## TEXAS COMMISSION ON ENVIRONMENTAL QUALITY

NAME OF PROJECT: **Purgatory Road Substation**; Located approximately 0.70 miles northeast of the Purgatory Road and FM 306 intersection; Comal County, Texas

TYPE OF PLAN: Request for Approval of a **Water Pollution Abatement Plan (WPAP)**; 30 Texas Administrative Code (TAC) Chapter 213 Edwards Aquifer

SECTION C-C'  
SCALE: 1"=20' (H)  
1"=2' (V)

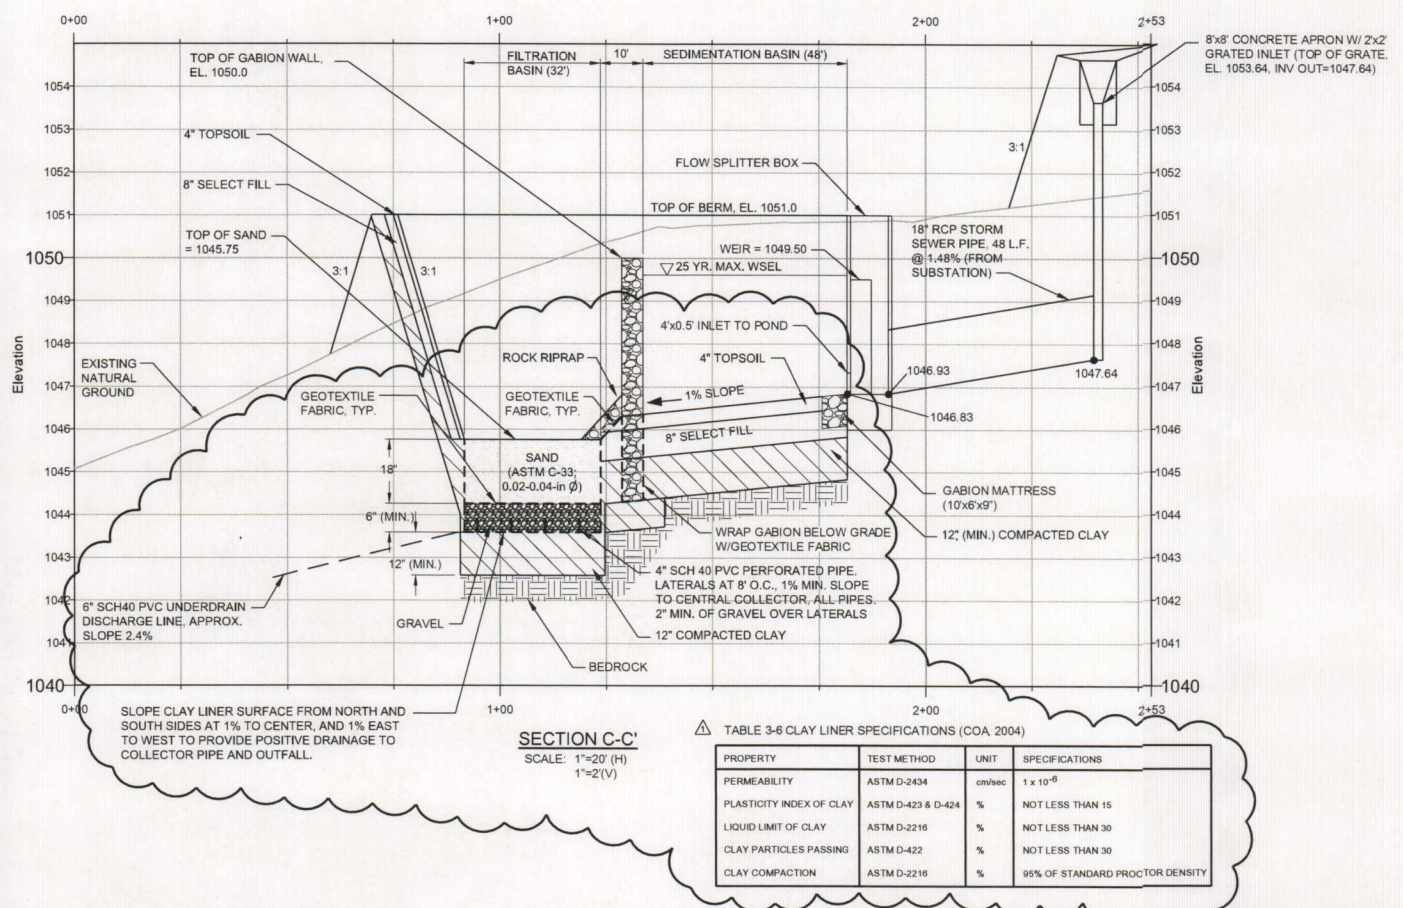
Section C-C as listed on sheet 0600 F-6 shows a slight drop in elevation from the top of the sedimentation chamber floor to the top of the sand within the sand filtration chamber. As water flows into the sand filter area this elevation change could cause erosion of the sand at the point of impact potentially causing a gouging effect. Please revise the current design to prevent erosion at this location.

**PEC Response:** Section C-C' on Sheet 0600 F-6 has been revised to change the 0.5-foot elevation change at this location from a vertical drop to a slope, and to include rock riprap on the ground surface of the area to prevent gouging and erosion of the sand by water flowing through the gabion wall. A copy of the revised plan sheet 0600 F-6 is attached to this letter.

**PEC Response:** Section C-C' on Sheet 0600 F-6 has been revised to indicate a 1% slope in the lateral underdrain pipes and the central collector pipe within the sand filtration underdrain, and 1% slopes on the finished surface of the compacted clay liner. A copy of the revised plan sheet 0600 F-6 is attached to this letter.

**PEC Response:** Specifications for the clay liner have been added adjacent to Section C-C' on plan sheet 0600 F-6. A copy of the revised plan sheet 0600 F-6 is attached to this letter.

Pedernales Electric Cooperative, Inc. Purgatory Road Substation			
<b>CONSTRUCTION DETAILS - TEMPORARY STORM WATER BMPs</b>			
Comal County, Texas			
By: RJR-K2	Date: 10-8-2014	Project No. -	
amec			Sheet 0600 F-7

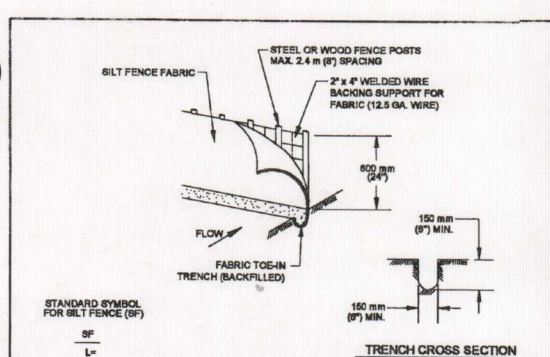
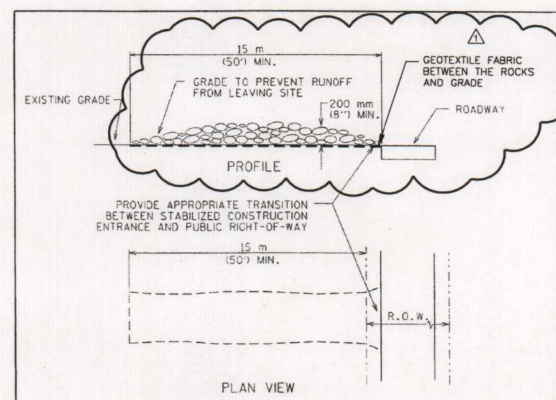
The temporary construction entrance details listed on sheet 0600 F-7 do not include the use of geotextile fabric. Please review the temporary construction entrance section of RG-348, Complying with the Edwards Aquifer Rules: Technical Guidance on Best Management Practices, located on pages 1-63 through 1-65, and submit a corrected detail sheet that includes the geotextile fabric.

**PEC Response:** The construction detail for the stabilized construction entrance has been revised to show geotextile fabric between the rock and the underlying soil. A copy of revised plan sheet 0600 F-7 is attached to this letter.

FRENCH DRAIN  
DETAIL I  
NTS

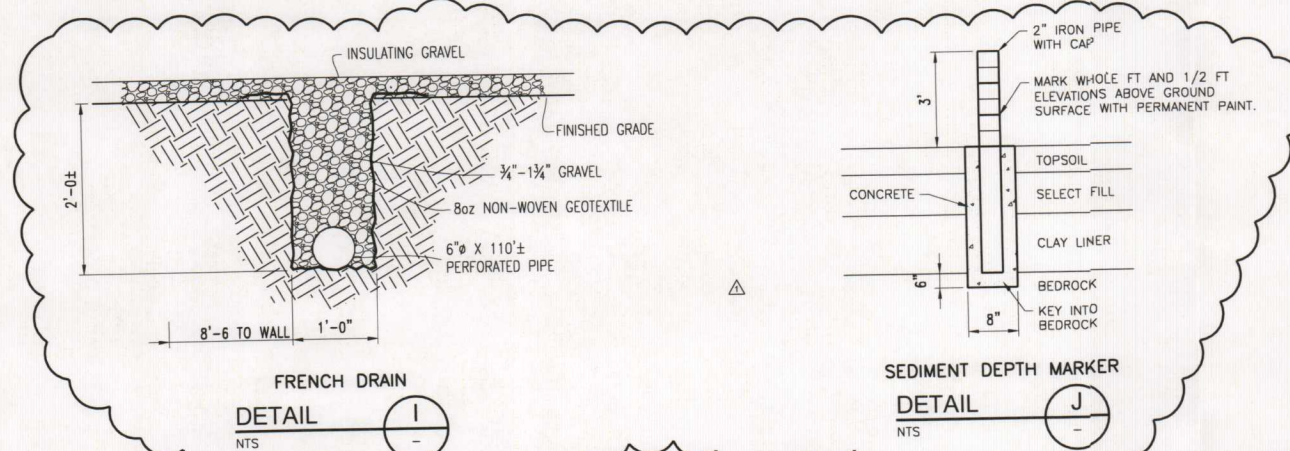
The 6 inch PVC French drain system that is displayed on schematic sheet 0600 F-3 does not have a detail sheet associated with it. Please provide a detail sheet that displays the dimensions of the drain system, liners, fill materials, etc.

**PEC Response:** A detail showing the French drain system dimensions, liners and fill material has been added to Sheet 0600 F-8, and references to the detail have been added to Sheets 0600 F-3 and 0600 F-5. Copies of revised plan sheets 0600 F-3, 0600 F-5, and 0600 F-8 are attached to this letter.
